# CITY OF ALBUQUERQUE

RE: **Lot 16 Block 6 SAD 228**  
**6220 Camino Alto NW**  
**Volcano Cliffs Subdivision**  
**Grading and Drainage Plan**  
**Engineers Stamp Date 7/6/18 (D10D003B16)**

Based upon the information provided in your submittal received 7/6/18, this plan cannot be approved for Grading Permit until the following comments are addressed.

ENGINEER'S SEAL  7/6/18 DAVID SOULE P.E. #14522	6220 CAMINO ALTO	DRAWN BY: WCVJ
	GRADING AND DRAINAGE PLAN	DATE: 7-06-18
	 Rio Grande Engineering 1606 CENTRAL AVENUE SE SUITE 201 ALBUQUERQUE, NM 87106 (505) 872-0999	218126-LAYOUT-7-06-18
		SHEET #
		JOB # 218126

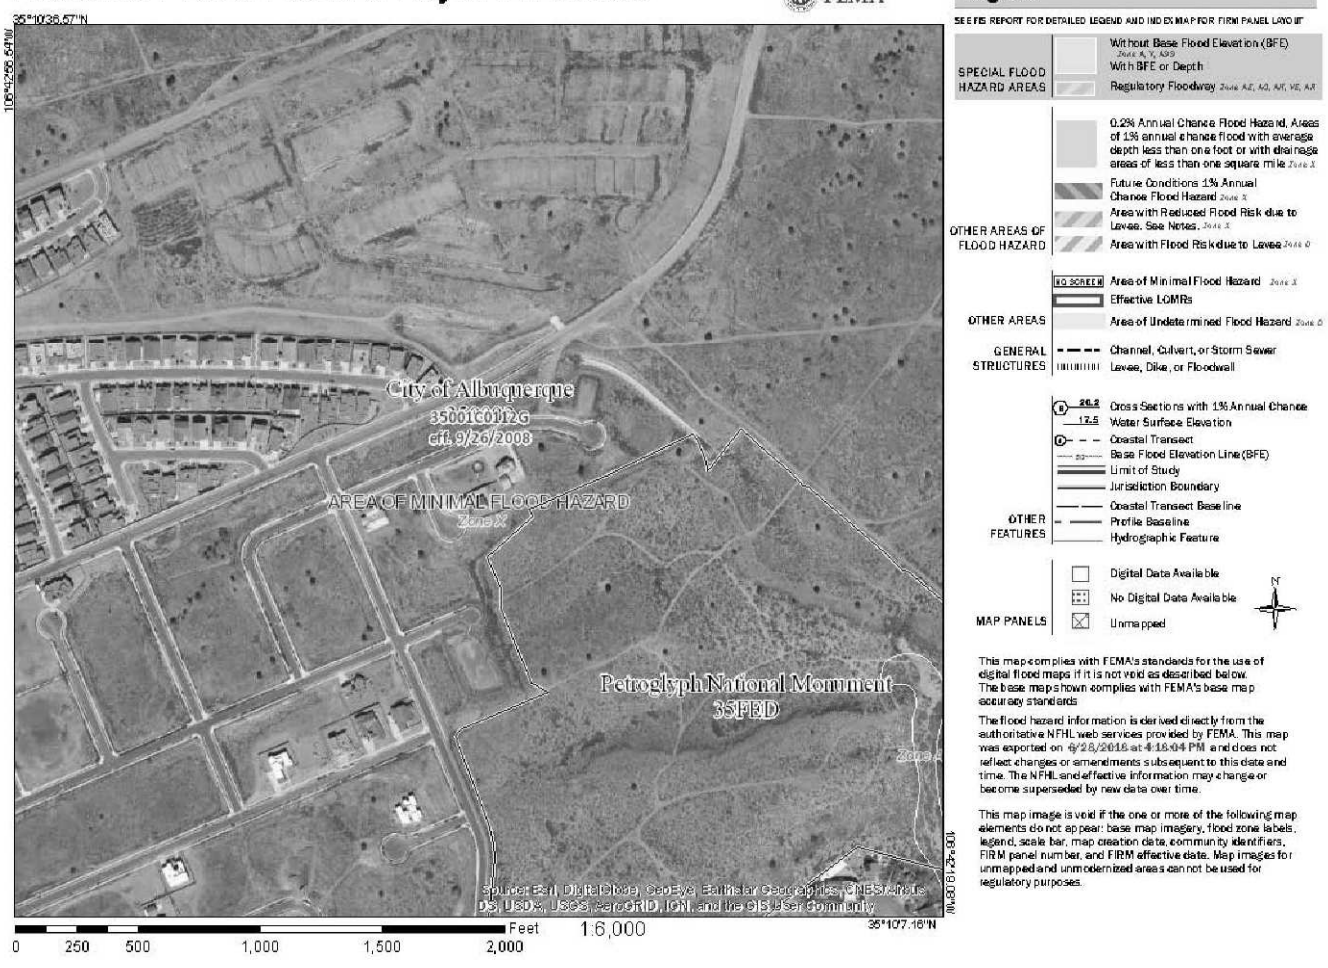
- Show the 10' PUE in the rear yard and side yard.
- Provide one FF elevation.
